Objection: Planning application R/84/26/PL

Location: Ground floor, 55-57 Sea Lane, Rustington, BN16 2RN

Proposal: Installation of commercial kitchen extractor on rear facade of outbuilding, alterations to rear doors/windows, and covered walkway structure.

**The exhaust
is here**

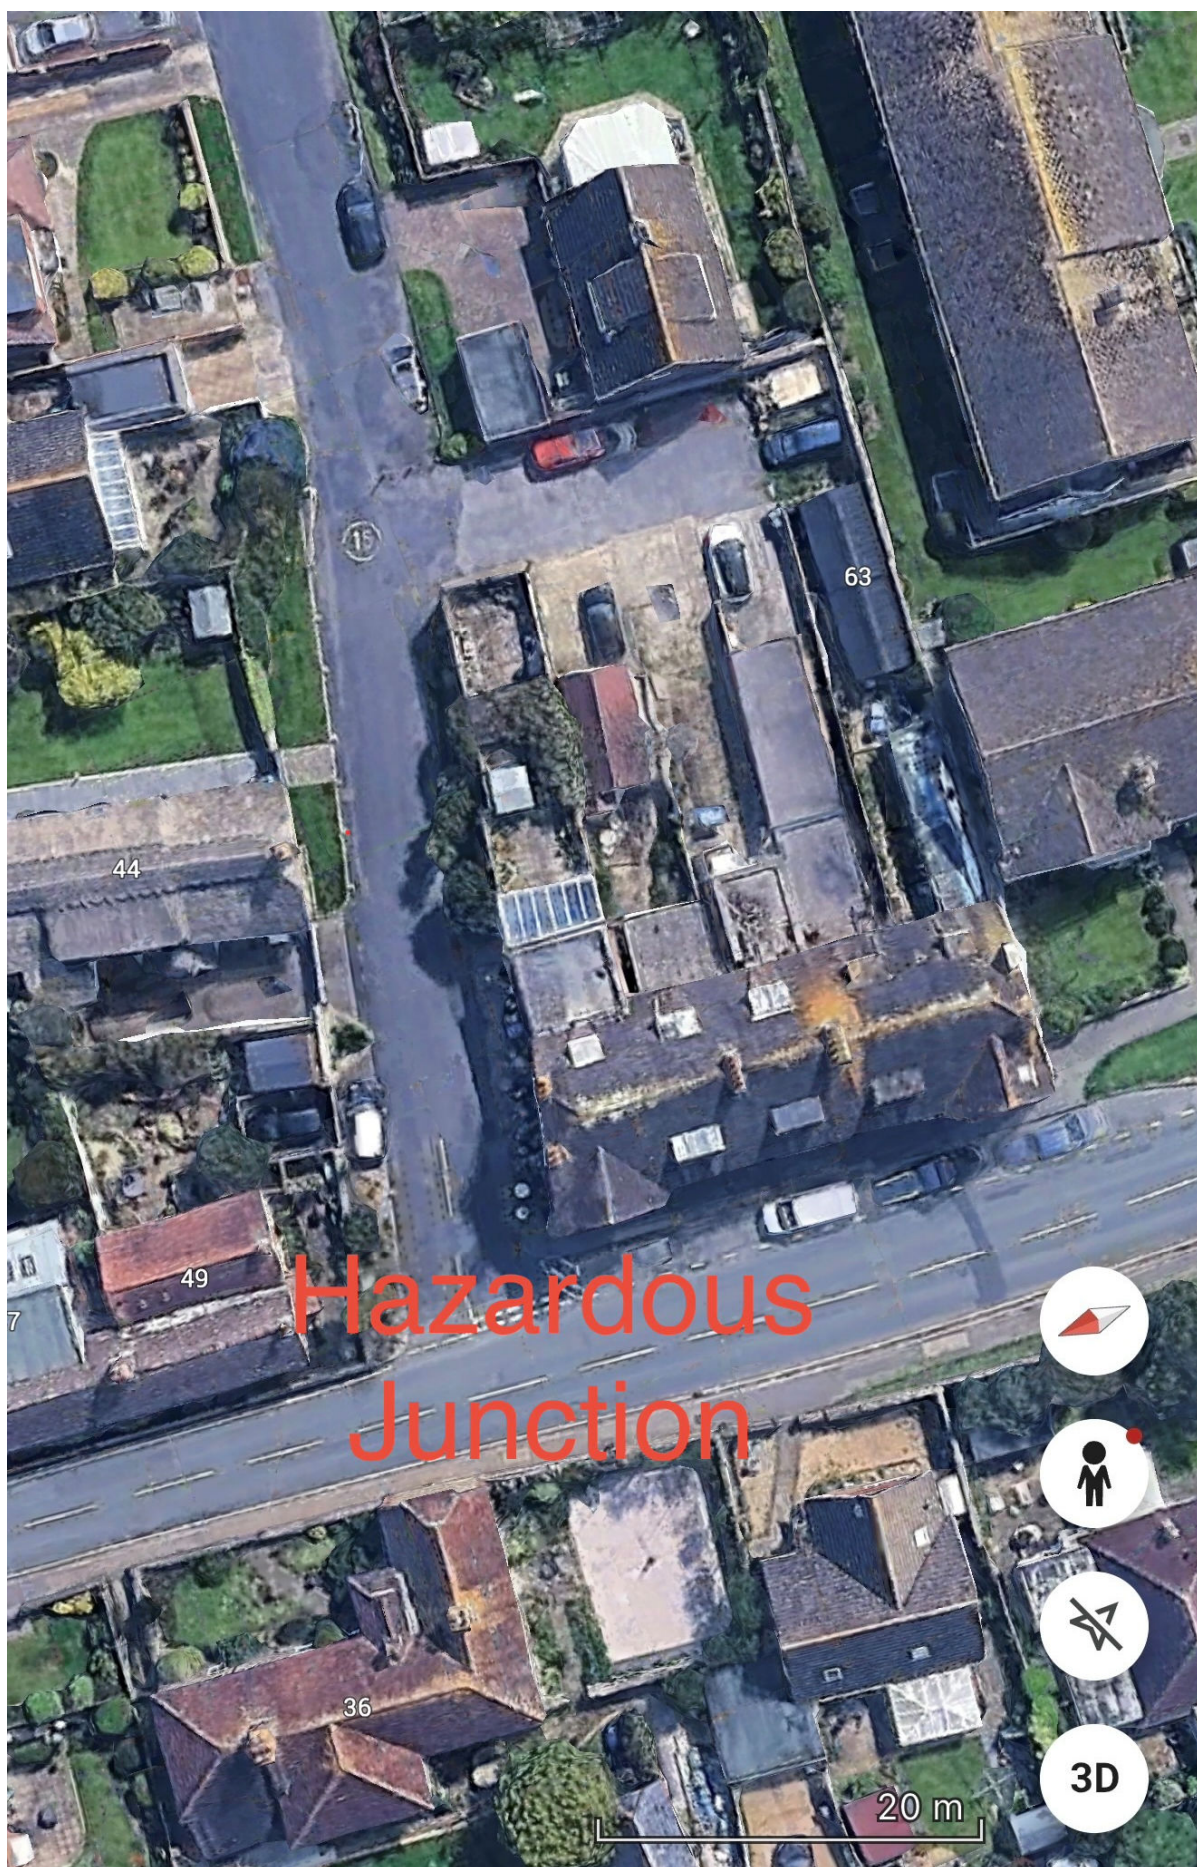
As noted by other representations, the submission documents are contradictory: the text states that a vertical discharge design will be used, whereas the architectural layout drawings explicitly illustrate a horizontal discharge exiting from a 90-degree bend. This 90-degree turn creates a sharp grease accumulation trap and a localized fire hazard. Furthermore, terminating a low-level flue on a low, single-storey garage roof, positioned just 11m and 14m from the nearest homes, and 2m from the adjacent first-floor terrace of 51/53 Sea Lane - will fail to clear the wind shadow of the dominant 3-storey main building block, trapping toxic smoke at ground-level.
